# REPORT OF THE SAFOD ENGINEERING SUBCOMMITTEE OF THE ADVISORY COMMITTEE FOR GEOSCIENCES, MARCH 30, 2011

## Subcommittee Members

The DIP was installed (Figure 4) in September 2008 at the conclusion of the MREFC project. The DIP used what was considered the best design and equipment that fit within a budget that was much smaller than originally planned. An original budget of \$2.56M had been reduced to less than \$0.4M due to overruns in the core recovery portion of the program. Moreover, NSF informed SAFOD that no additional funds would be made available under MREFC. As such, considerable sacrifice had to be made to the original design, including eliminating portions of the instrumentation – most notably the pore pressure sensor and the preferred use of HT electronics that had been recommended by Sandia for longevity. Unfortunately, within two weeks of deployment, all elements of the DIP ceased functioning. In response, the SAFOD Engineering Subcommittee (henceforth referred to as “the committee”) of the Advisory Committee for Geosciences was established in August 2010 and charged with:

Figure 3 SAFOD DIP Showing the Two Separate Control Lines

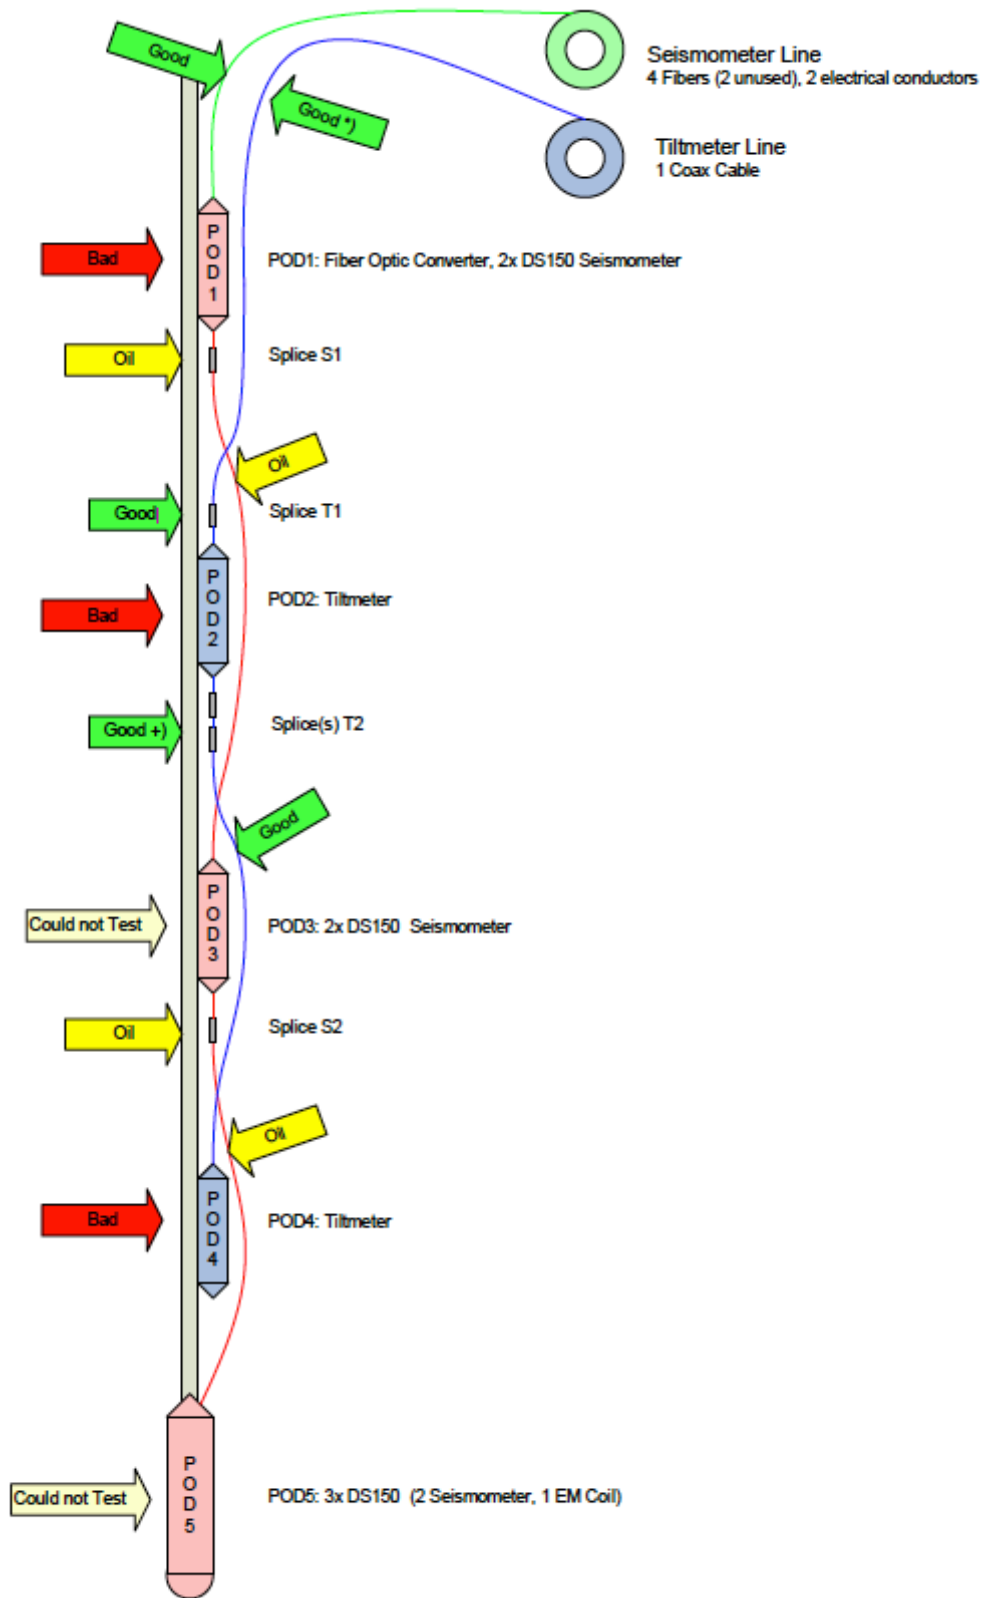
Because the entire DIP is approximately 300 feet long to accommodate vertical spacing between seismometers and tiltmeters, it was necessary to connect the Pods together in the field via splices between them (see Figure 3). The splicing was performed on the floor of the drill rig during DIP installation. Splices consisted of soldered connections of stripped ends with no additional strain relief, such as by twisting conductors together (Figure 8). The splices were housed in short sections of 3/8” tubes with Swagelok fittings at both ends (Figure 9). The committee felt that having splices was a design flaw, since the failure of a single splice could, under certain conditions, take out several all instruments in a string. An alternative would be to consider each Pod as an independent instrument, although arguably more costly.

- A broken wire was found in Splice S2 (see Figure 3). It is not clear if the break occurred before or during disassembly.

Figure 6 Spikes Developing in Seismic Data

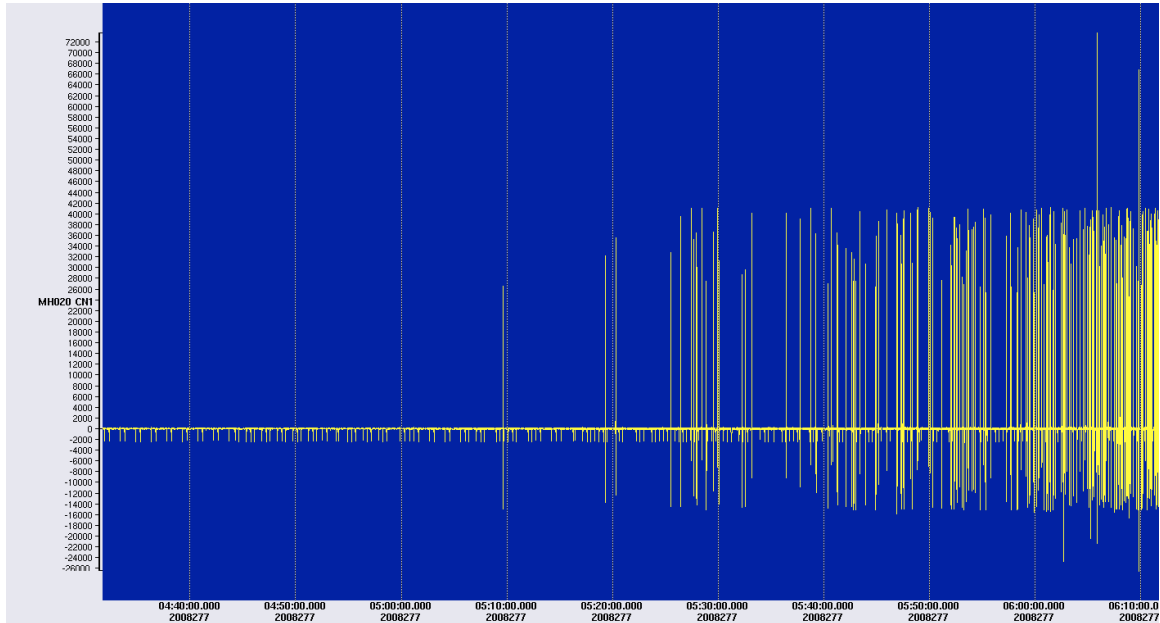
4. Communication problems developed shortly thereafter.
5. Approximately 10 days after deployment, all communication was lost with the exception of the instrument in Pod 1. Several days later the last instrument went into a spasm of dropouts, spikes (Figure 6) and reboots. Dropouts can be indicative of cable issues due to leakage or to premature electronic component failure.

Figure 8 Poorly Soldered Splices

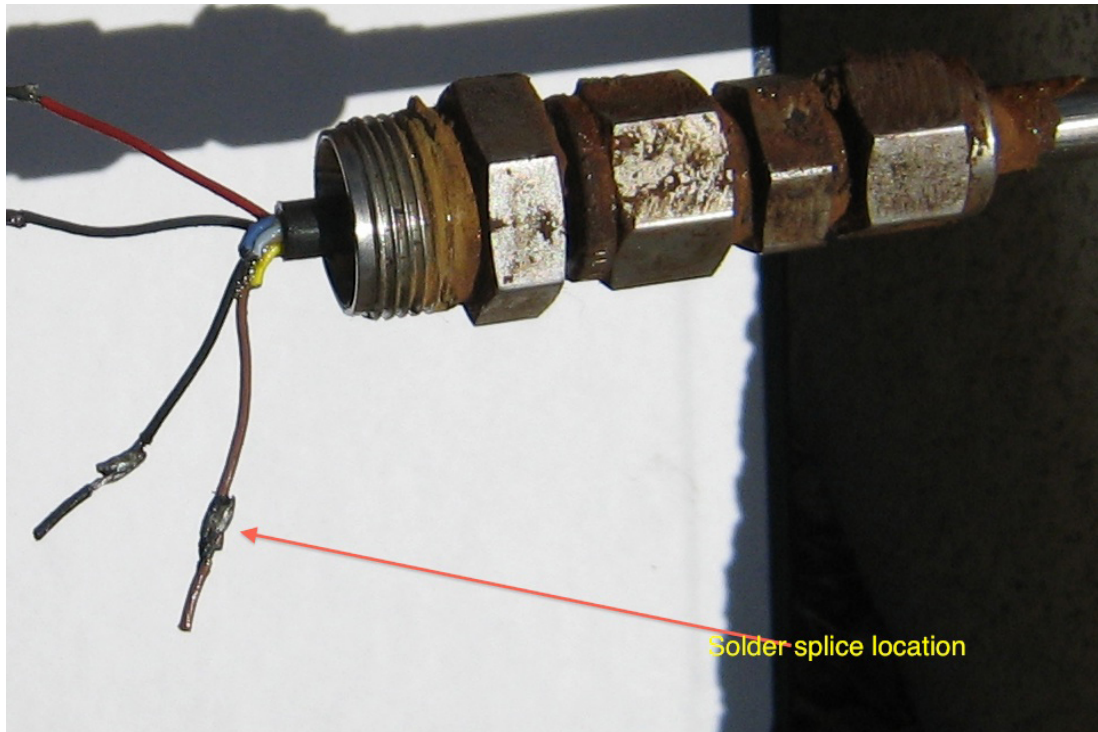
- The Mobil 1 had migrated between Pods through the ¼ inch tubing, indicating that the cable heads were probably compromised in some cases.
- Electrical splices between Pods were poorly done. The exposed ends of the wires were placed parallel to one another and soldered with no mechanical connection (Figure 8). Individual splices within their protective steel tubes were not staggered. A broken brown wire was found to have occurred near splice S2 between Pods 3 and 5. Insulation materials around the soldered connections had badly deteriorated in many cases. This may have allowed conductive fluid that migrated along the ¼ inch tubing and into the splices to create short-circuits between individual splices.

Figure 10A Pod Cap and Top of Cable Head.

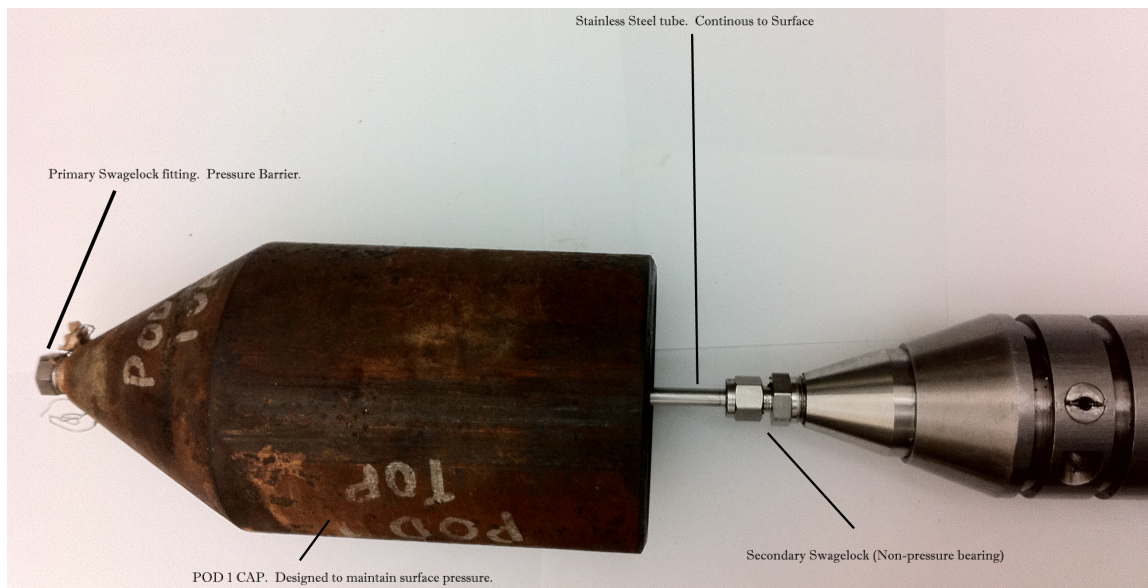
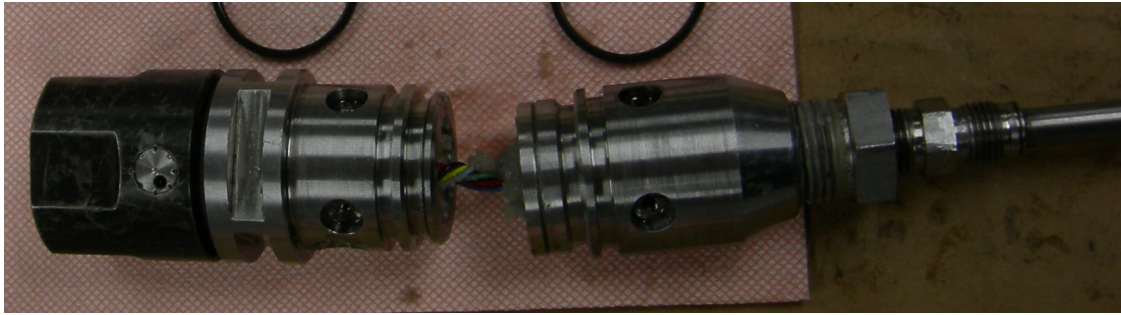
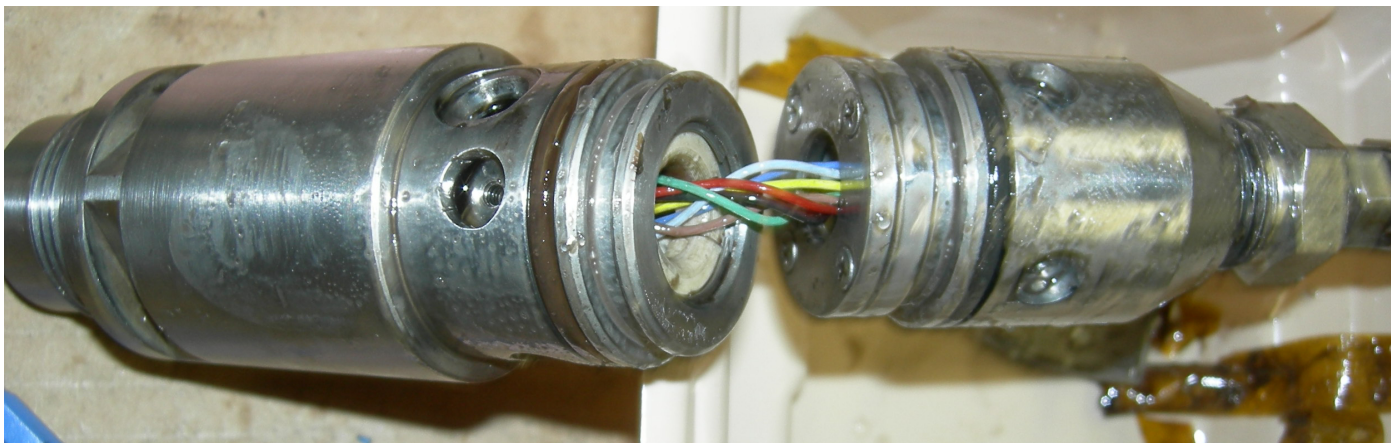
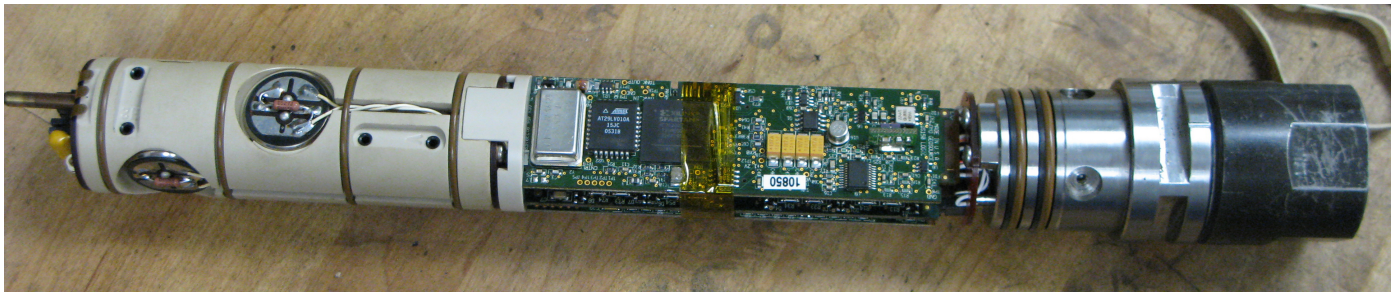
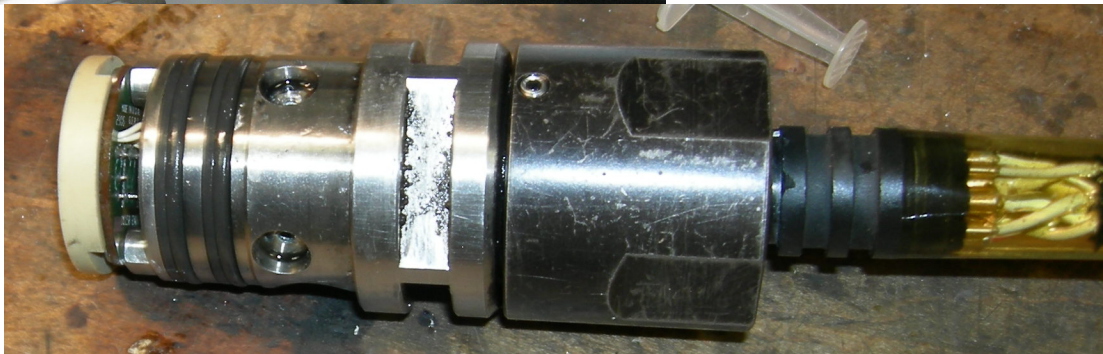
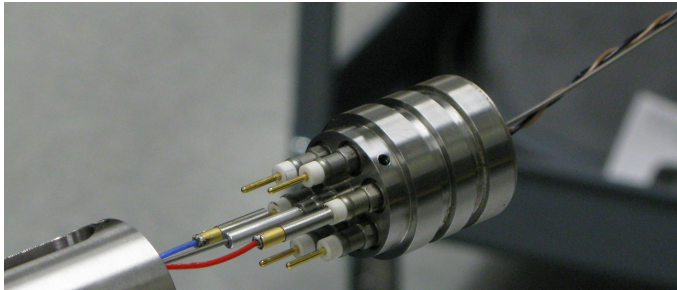
- ❖ The committee recommends that further study be performed on the actual O-rings and feeds-thru (Figure 10) used in the DIP to determine if they maintained integrity (blocking fluid, gas, and volatiles) during the two years the DIP was in the SAFOD borehole. It would also be useful to perform various stress tests on Swagelok fittings to determine if they can hold up under the rigors of installation, as well as for long periods under corrosive fluid and gas conditions.
